PLANNING COMMISSION AGENDA REPORT

SUBJECT: PLANNING APPLICATION PA-07-53
257 16TH PLACE

DATE: FEBRUARY 28, 2008

The applicant is proposing to construct a 3-unit, 2-story residential common interest development with variances from driveway parkway landscaping and vehicle back out distance requirements, a minor modification for reduced driveway width, and a minor design review for second-to-first floor ratios and average second floor left side setbacks.

SITE PLAN

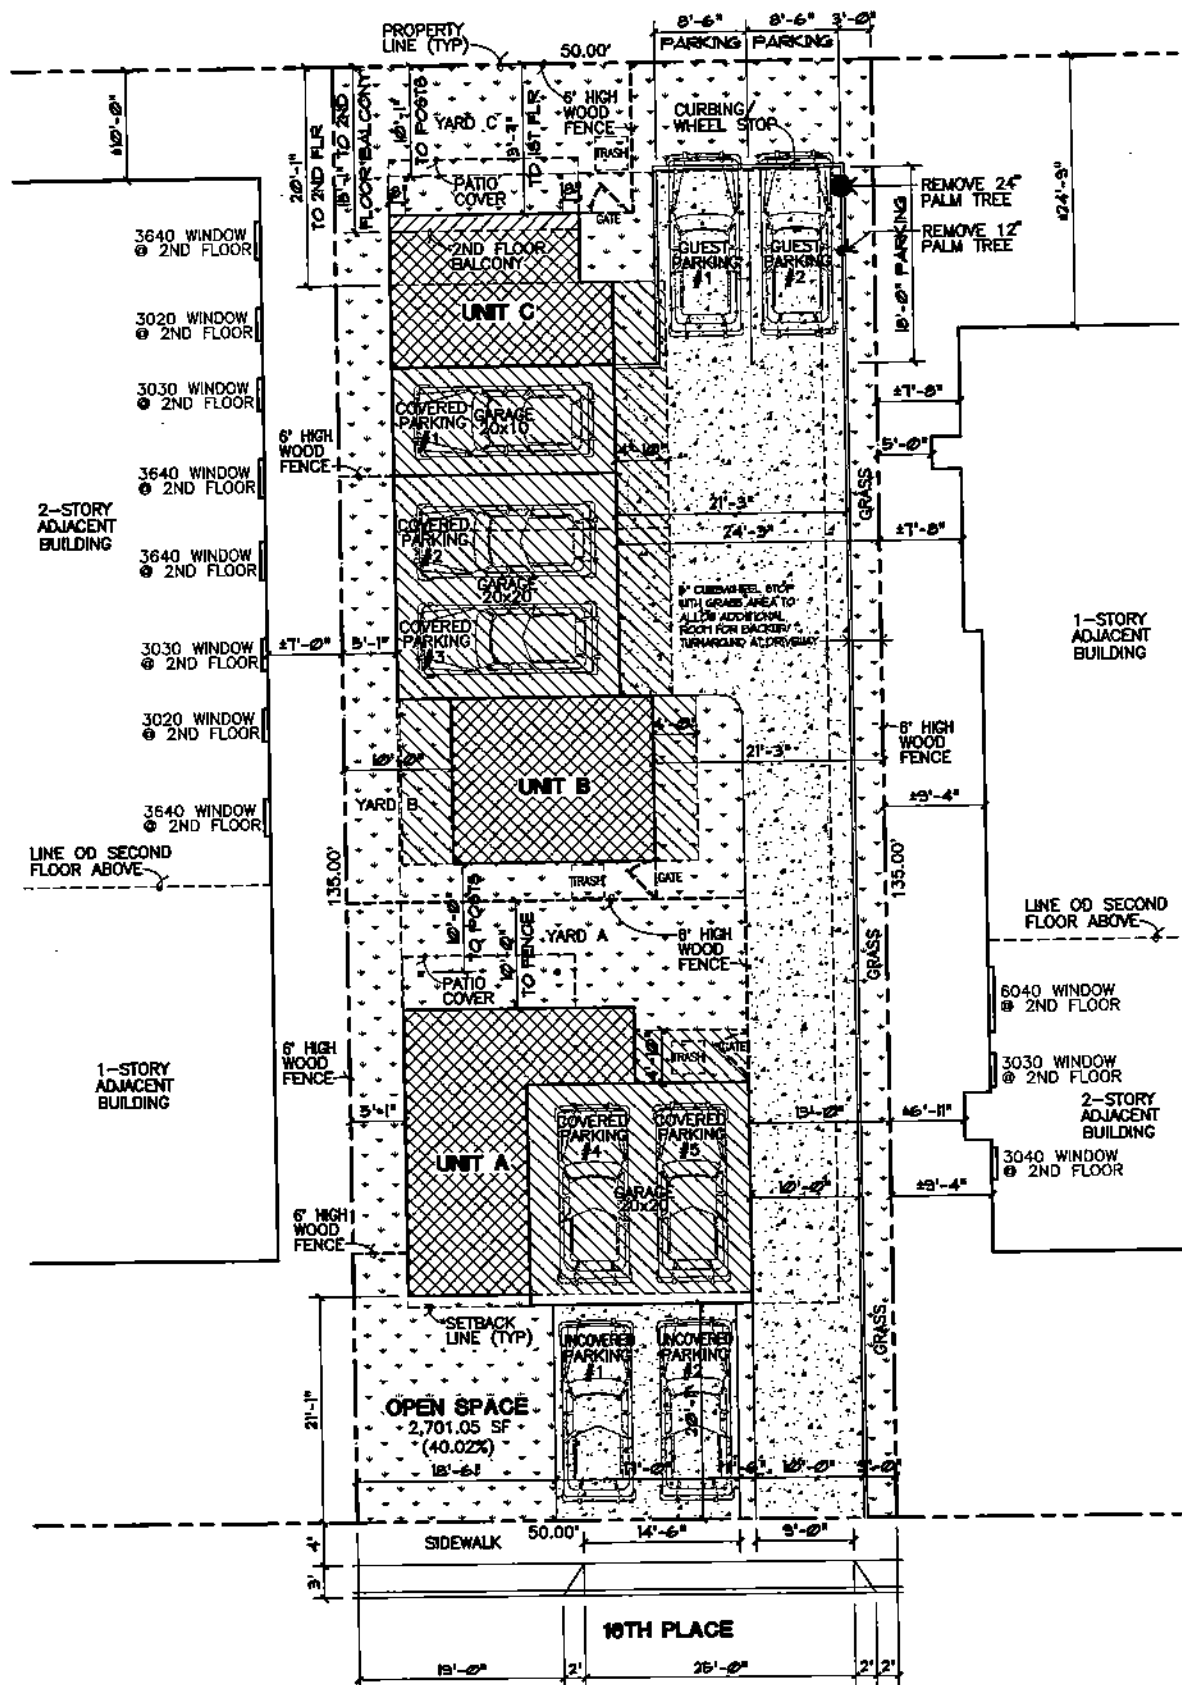
The applicant requests approval of a variance from the 25-foot vehicle back-out distance requirement to accommodate the project. According to Transportation Services Division, the back-out distance may be reduced to 23 feet for an 18-foot wide double garage door or 9-foot wide single wide door. However, the applicant proposes 21 feet to the landscape curb for the 3 garage spaces between units B and C. Although there is a 24-foot setback between the garage spaces and the right side property line, removal of any landscaping would result in a shortage of open space.

It is staff's opinion that application of the vehicle back-out requirement will not deprive the property of privileges enjoyed by others in the vicinity under the same zoning district because the nonconforming lot width and area do not preclude a project from providing adequate on-site circulation. There have been many projects on nonconforming lots that were successfully designed to meet this requirement. The proposal also lacks an on-site turnaround area to allow all vehicles to exit in a forward direction. The 2 guest parking spaces at the rear of the lot are required to back out more than 100 feet on to 16th Place. It is staff's opinion that the insufficient on-site circulation creates an unsafe project design.

The applicant also requests approval of a variance from driveway parkway landscaping (5 feet minimum on house side and 10 feet combined width required; 0 feet on house side and 4 feet combined width proposed).

It is staff's opinion that the lot's nonconforming 50-foot width (100 feet required) creates the justification for approval of a variance from driveway parkway landscaping requirement since the nonconforming lot provides limited area to accommodate the required 16-foot driveway, 5-foot side building setback, and a 10-foot combined width for driveway parkway landscaping. However, the intent of the driveway parkway landscaping requirement was to provide visual relief for common driveways serving multiple dwelling units. It is staff's opinion that the 3-foot landscape strip (2.5 feet after installation of a 6-inch curb) along the right side property line and a 1.5-foot (.5-foot after installation of a 6-inch curb) strip between driveways are not sufficient in breaking up the paving that is visible from the street. Specifically, approximately half of the lot is proposed to be paved within the front setback and no landscaping is provided along the left side of the driveway behind the front setback.

Although staff feels that special circumstances to the property exist to justify approval of a variance for reduced driveway parkway landscaping, staff is not recommending approval of the proposed design because it does not meet the intent of the driveway parkway landscaping requirement.

The applicant requests approval of a minor modification for reduced driveway width (16 feet required; 10 feet proposed).

the driveway to enhance the development. However, the reduced driveway width along with the requested vehicle back-out variance will not provide adequate on-site circulation. The Transportation Services Division does not support the reduced driveway width because no on-site turnaround area is provided. Therefore, staff does not support the minor modification request.

2. **25' turning radius:** We have widened the garage doors which reduces the requirement to 23'. There is a 3' wide grass area at the side property line which is bordered with a 5" low curb which would allow the front or rear of a vehicle to overhang it during a turn-around. So effectively we have 24'-3" of turnaround although officially it is 21'-3". This area could be paved to bring up the official turn around space but then I would need to ask for a variance to have 39% open space. (I would be ok with this.) Finally, the consumers who purchase the back condos will have been able to see for themselves whether the turn around distance is acceptable to them or not before they decide to purchase.

3. **Minor Modification for a 10' drive way width:** This is necessary due to the narrowness of the lot. There are only two units which have a total of 3 bedrooms that this driveway serves.

4. **Parkway landscape widths:** It is not possible to meet this rule on a 50' lot nor do I feel it is necessary. Designing this project within the cities constraints on the narrow lot has already caused the structure to occupy less than 30% of the existing lot space. Thus the concern of over structure density should be relieved since it is so low.

SIDEYARD VIEW (ALL UNITS)

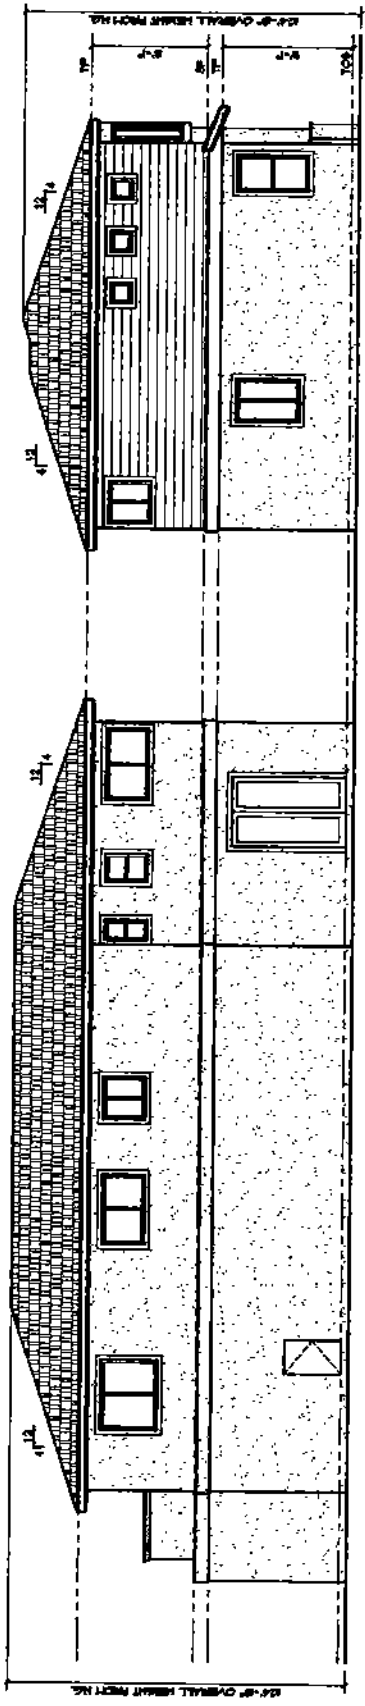
To minimize second story mass, the City's residential design guidelines recommend that the second floor not exceed 80% of the first floor area and the second story be set back an average of 10 feet from the side property lines. The proposed second floors are 105% and 122% of the first floors, and a 5-foot second floor left side setback. Staff is not opposed to the second-to-first floor ratios since their size and scale are compatible with other 2-story structures in the area. However, it is staff's opinion that although the setbacks and placement of windows are designed to minimize privacy impacts and direct views into windows on adjacent properties, the 5-foot second floor left side setbacks along the entire length of both buildings (27 feet for unit A and 54 feet for units B and C) create stark elevations and a boxy appearance which are inconsistent with the intent of the design guidelines.

- A. The information presented does not comply with Costa Mesa Municipal Code Section 13-29(14)(a) in that although the scale of the buildings are compatible with structures in the area, the 5-foot second floor left side setbacks along the entire length of both buildings create stark elevations and a boxy appearance which are inconsistent with the intent of the design guidelines. Additionally, the project as a whole does not include provision of the minimum required vehicle back-out distance, driveway width, and on-site turnaround area.

1. Minor design review: 80% second floor ratio and 10' average side setback. It was necessary to locate the building at the 5' side setback line due to the narrow lot size (50'). We will still provide visual articulation on this side with the use of foam window sills and trim, belly band, and pot shelves. Inspection of the neighborhood will confirm that our proposed structure would be the least boxy home on the entire block. (see attached pictures)
